### **Review of Auckland Airport's 2022 – 2027 Price Setting Event 4 (PSE4) – Consultation paper: Air New Zealand (Air NZ) Cross Submission**

## Air NZ's cross submission on responses to the consultation paper

Figure 1: Air NZ / Arup Benchmarking, with AIAL and Air NZ annotations

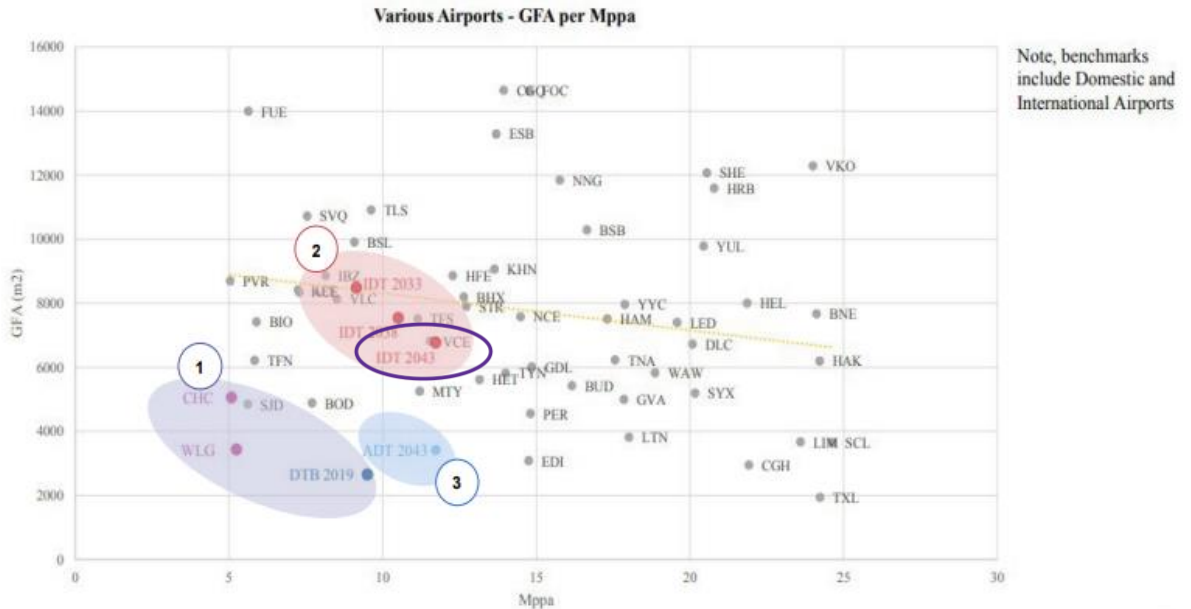
- 3.6.1 The graph depicts only airports which have capacity for 5 million pax per annum or higher (the current DTB is ~6 million pax) and therefore excludes all airports which are smaller than this, of which there are many.

- 3.6.2 AIAL’s comment suggests it has missed the key information depicted in the graph: the terminals around or above the trendline represent terminals built with a higher LoS (international IDT and/or hub terminals).

- 3.6.3 Contrary to AIAL’s view, using WLG and CHC as benchmarks helps illustrate the domestic and international service requirements here in New Zealand and therefore what an appropriate LoS may look like for an NZ domestic terminal. This context should be part of the consideration for AIAL rather than being dismissed on the basis that other global international airports, which have a different customer base, are bigger.

- 3.6.5 Furthermore, Air NZ believes there are several items which should change the position of the DJT on the current graph. These are:
- 3.6.5.1 The size of the proposed DJT does not include space for check-in, as this is incorporated in the existing international check-in space. All other terminals include this space and including it for the DJT would add ~200m<sup>2</sup> per mppa in 2033 (~600-800 sqm in total) and would push the DJT to be even higher on the chart than the international airports it is compared against.
